UNITED STATES PATENT AND TRADEMARK OFFICE

APPLICATION NO.	FILING DATE	FIRST NAMED INVENTOR	ATTORNEY DOCKET NO.	CONFIRMATION NO.
10/510,423	04/21/2005	Jaume Prat Terradas	30607/40513	4333
4743 7590 08/10/2007 MARSHALL, GERSTEIN & BORUN LLP 233 S. WACKER DRIVE, SUITE 6300 SEARS TOWER CHICAGO, IL 60606			EXAMINER LUONG, VINH	
			ART UNIT 3682	PAPER NUMBER
			MAIL DATE 08/10/2007	DELIVERY MODE PAPER

Office Action Summary

ATTACHMENT 1

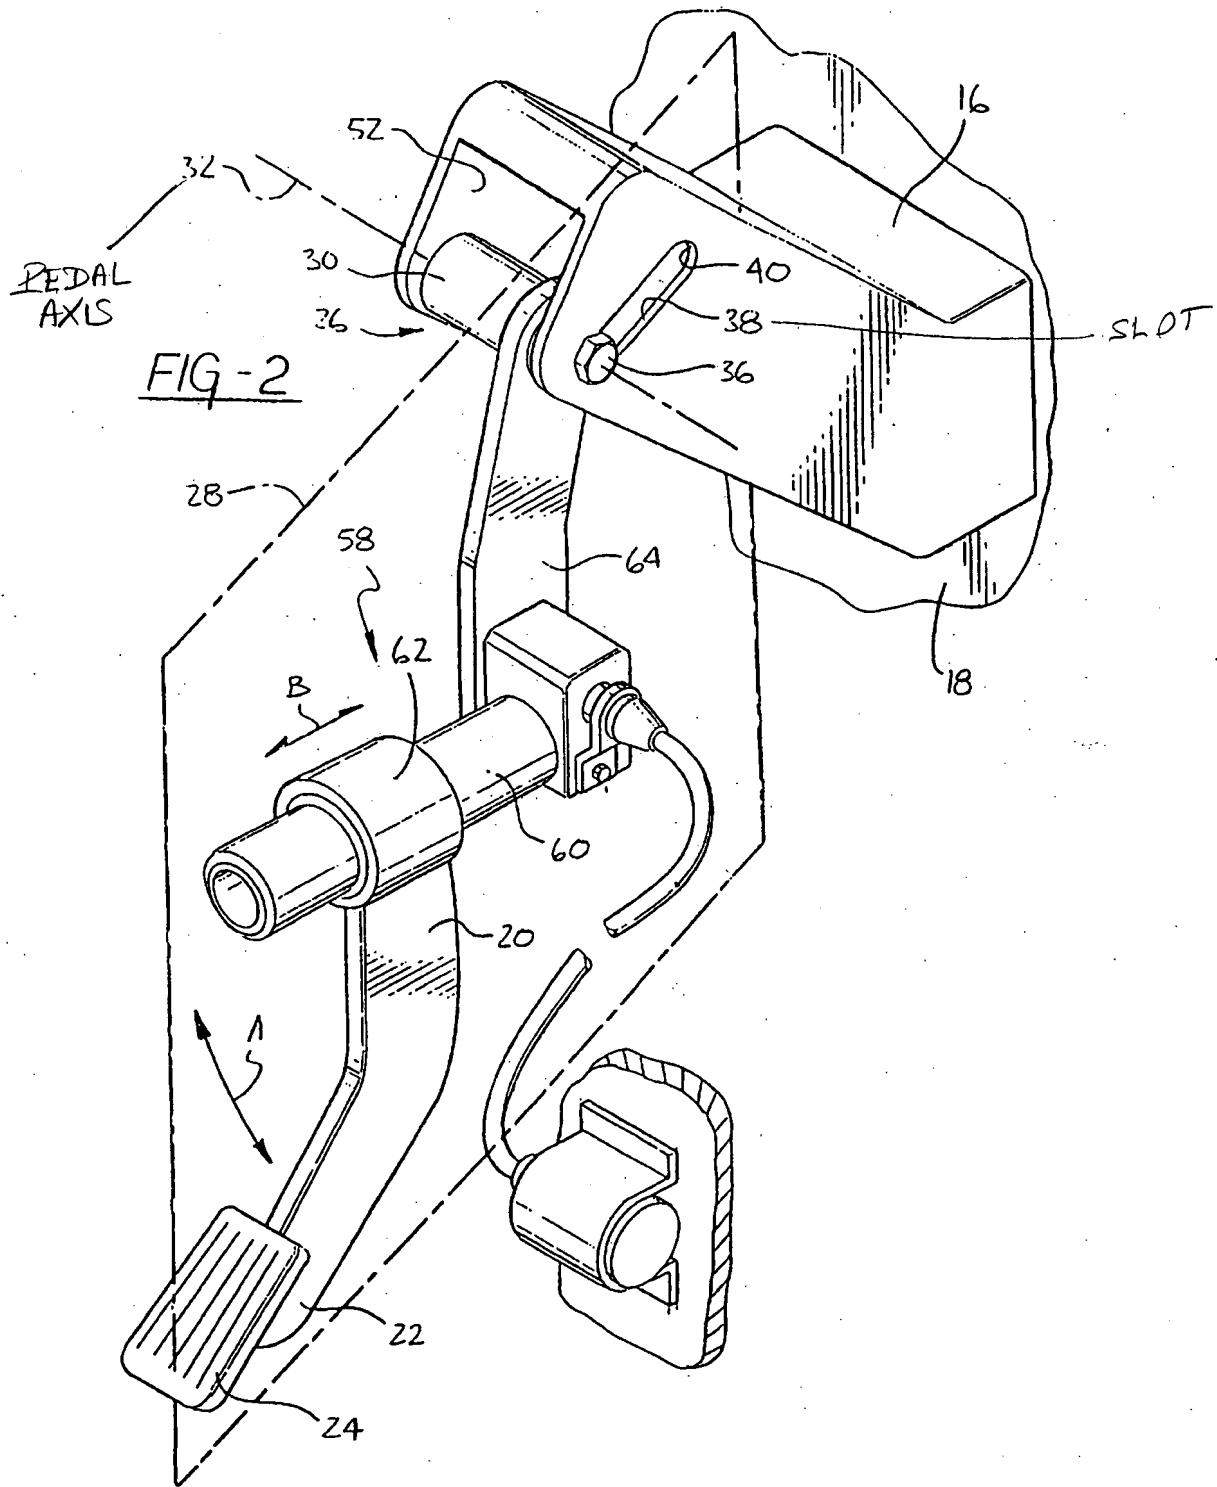
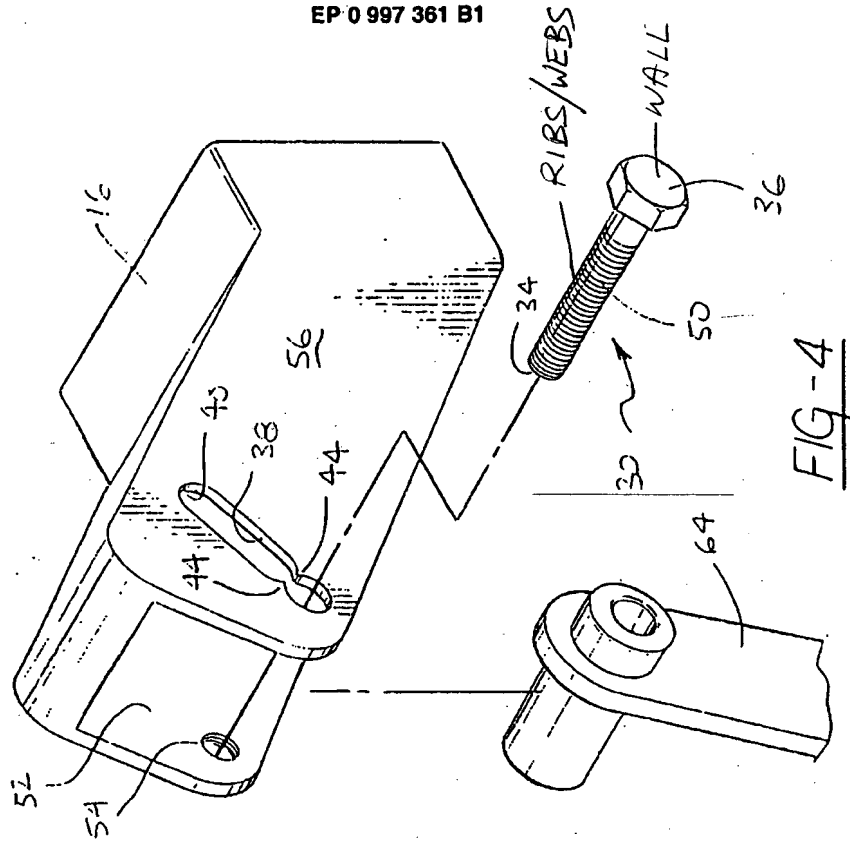
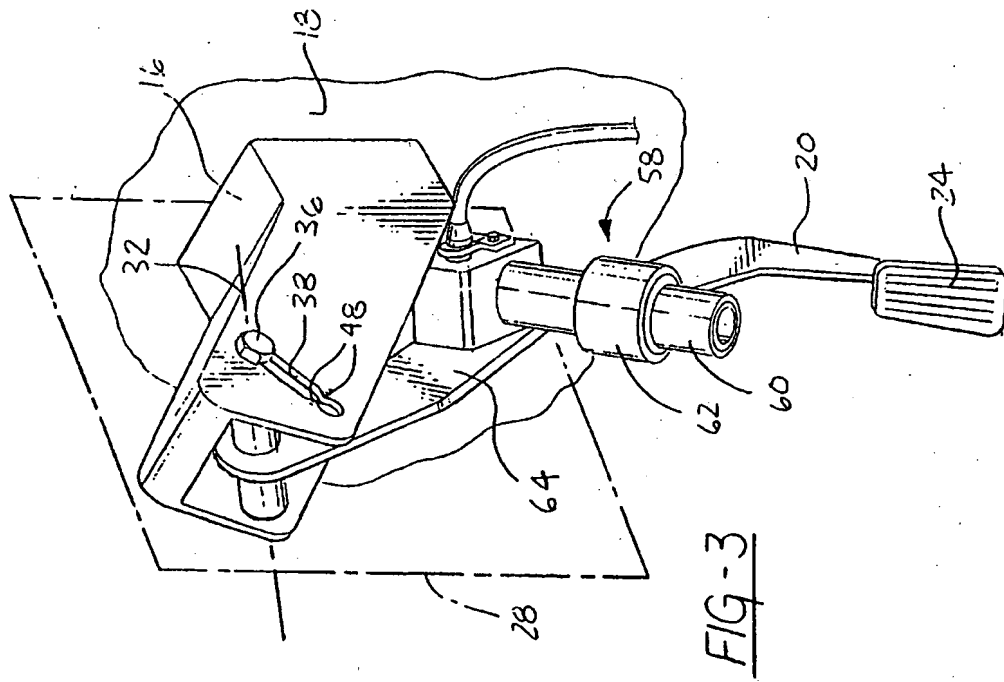
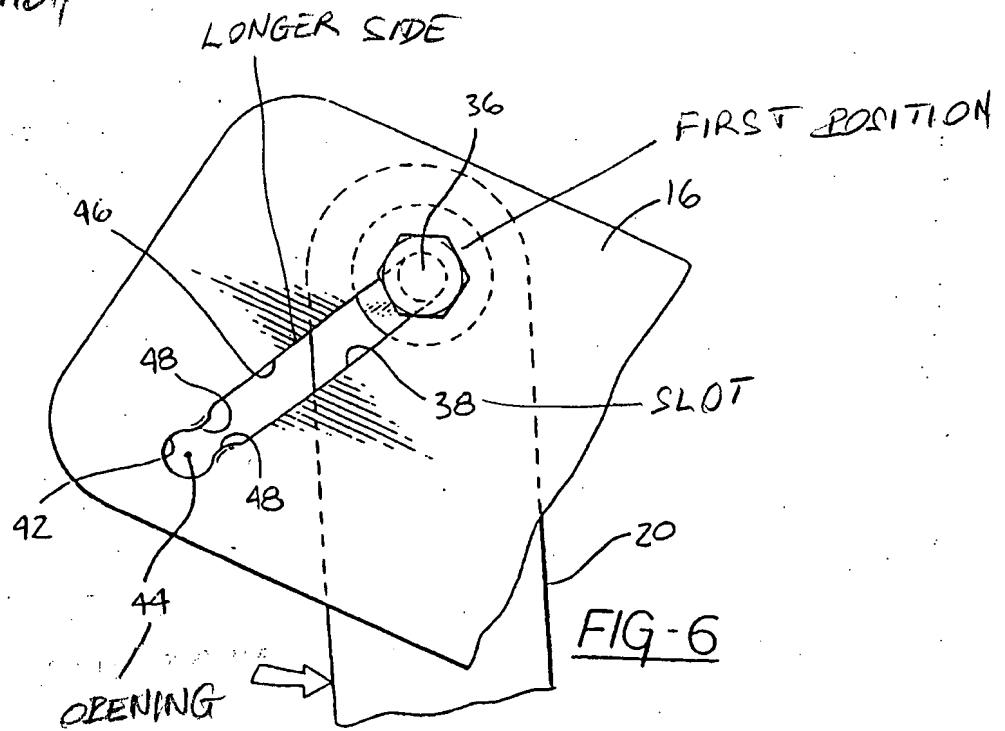
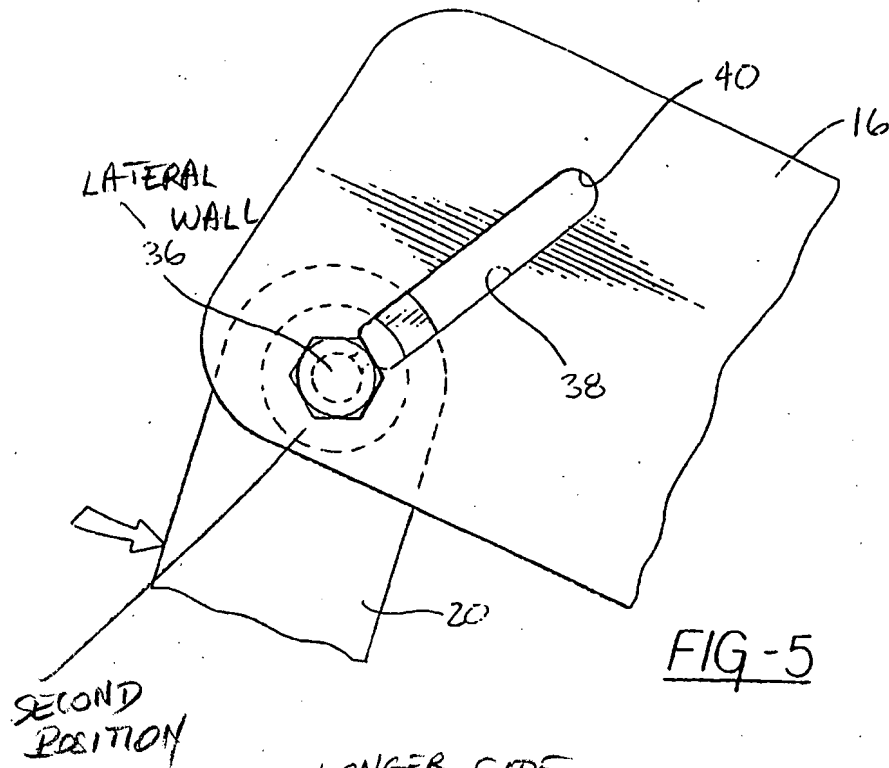
an opening 44 (see FIG. 6 in Attachment 1 hereinafter "Att. 1") for receiving and retaining the pedal axis 32, 30; and

a slot 38 connected to the opening 44 and defining longer sides 46 (*id.* Paragraph [0013], Att. 1), the slot 38 comprising lateral walls 36 along slot longer sides 46,

the lateral walls 36 comprising ribs or webs 50 (FIG. 4 in Att. 1) that extend longitudinally in the slot 38,

the lateral walls 36 having a first position (FIG. 6) in which the lateral walls 36 project into the slot 38 and a second position (FIG. 5) in which the lateral walls 36 are moved out of the slot 38, wherein the pedal axis 32, 30 engages the lateral walls 36 and moves the lateral walls 36 from the first position (FIG. 6) to the second position (FIG. 5) by exceeding a mechanical limit loading of the pedal axis 32, 30 whereby the slot 38 receives the pedal axis 32, 30. *Ibid.* paragraph [0014] *et seq.* and Claims 1-19.

In the instant case, *Webster's II New Riverside University Dictionary*, 1994, defines “web” as “a structure of *threadlike* filaments spun by spiders or certain insect larvae” (emphasis added). Therefore, the threadlike filaments of the threads 50 of Ananthasivan's fastener/lateral walls 36 in FIG. 4 “read on” the claimed “webs.” As noted, the threads 50 of Ananthasivan's fastener 36 are equivalent to Applicant's threads/webs 52 in Applicant's FIG. 3A.

Fig. 2

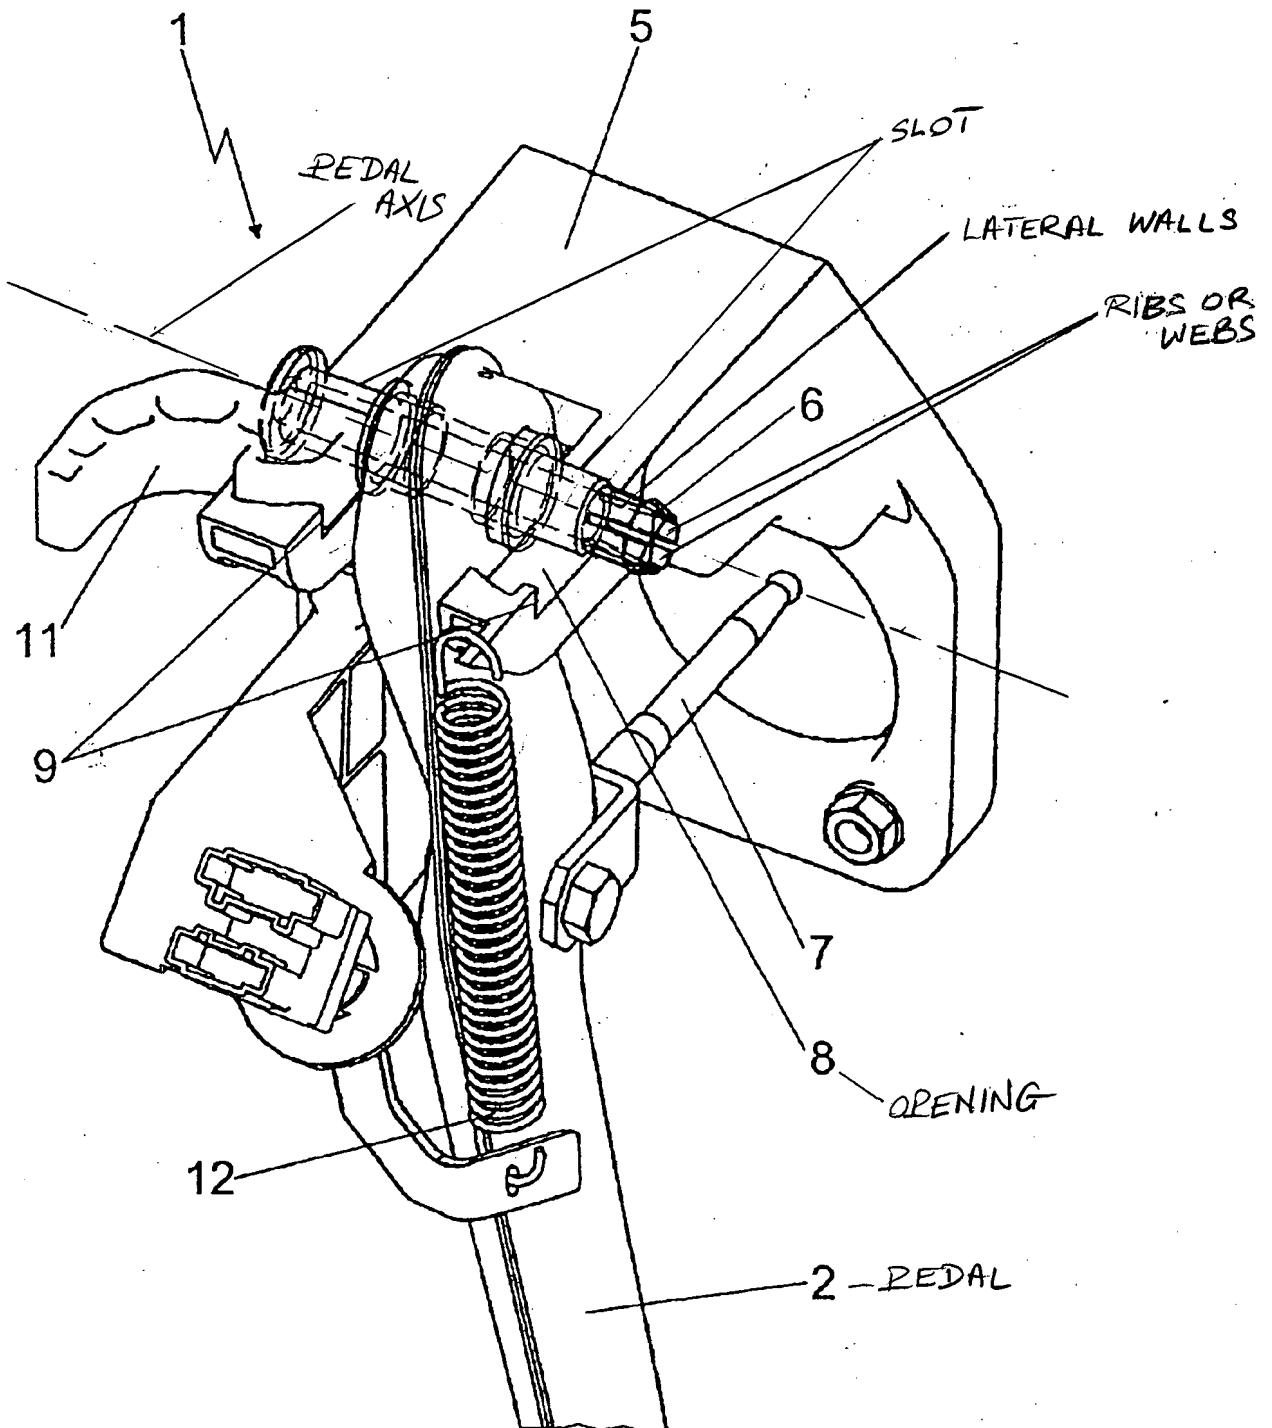
- a pedal 2 rotatably mounted by means of a pedal axis (see FIG. 2 of Attachment 2 hereinafter "Att. 2");

- a slot (unnumbered in FIGS. 2 and 5 in Att. 2) connected to the opening 8 and defining longer sides 6, the slot (Att. 2) comprising lateral walls 6 along the slot longer sides 6,

- the lateral walls 6 comprising ribs or webs (the ribs or webs are spaced from each other by gaps as seen in FIGS. 2 and 5),

- the lateral walls 6 capable of having a first position in which the lateral walls 6 project into the slot (FIG. 5) and a second position (FIG. 2) in which the lateral walls 6 are moved out of

Regarding claim 10, the slot (FIG. 2 of Att. 2) defines a predetermined displacement path of the pedal axis (Att. 2).

Fig. 5

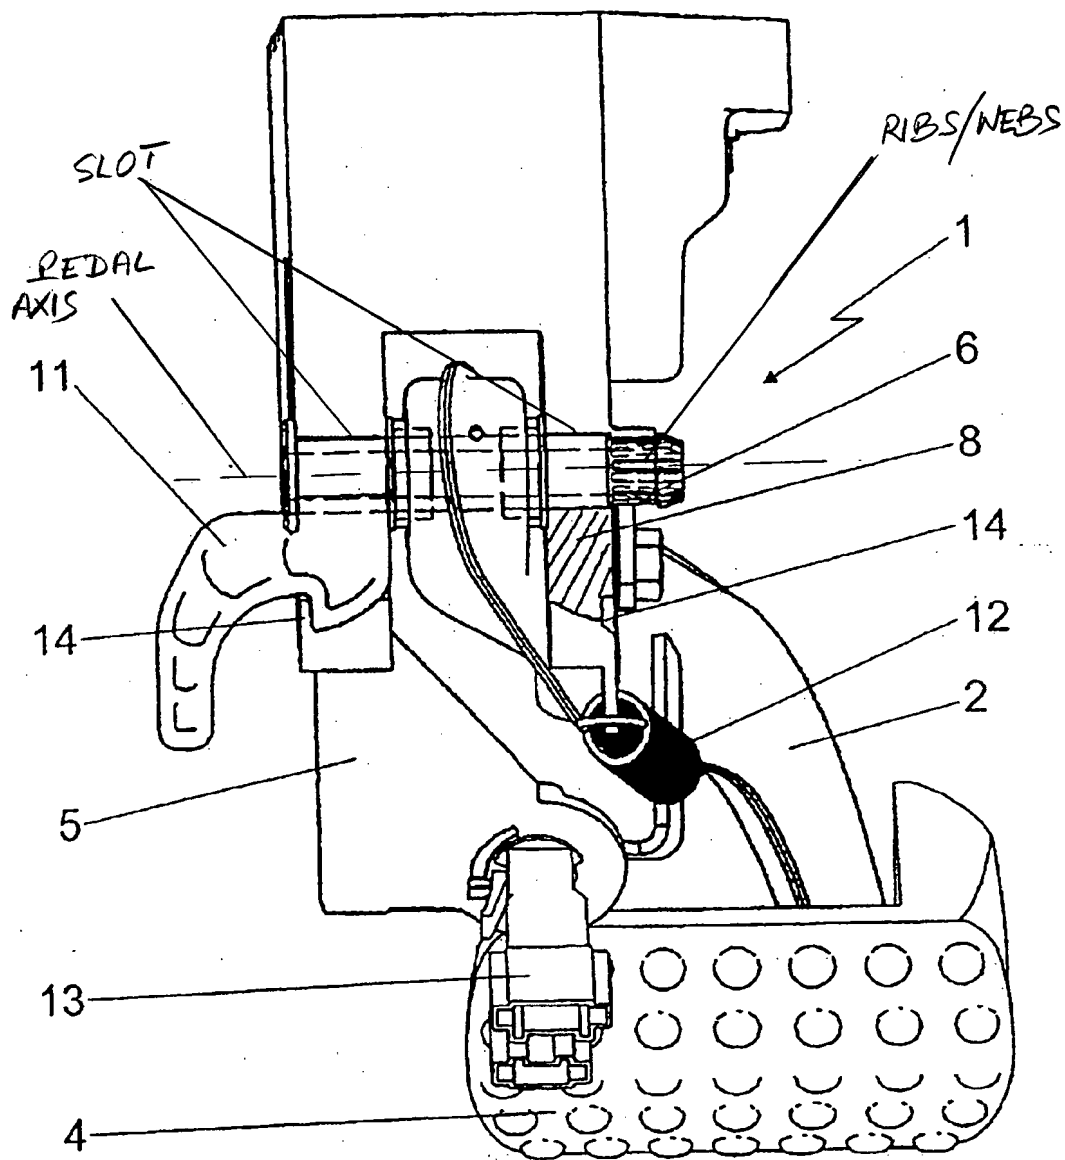
Regarding claim 11, the slot is formed by an elongated hole (FIG. 5 of Att. 2), which is partly closed by the lateral walls 6 projecting therein.

Regarding claim 12, the lateral walls 6 are capable of being bent, dismounted, or pushed away from the slot (FIG. 5 of Att. 2) in response to the mechanical limit loading by the pedal axis (Att. 2).
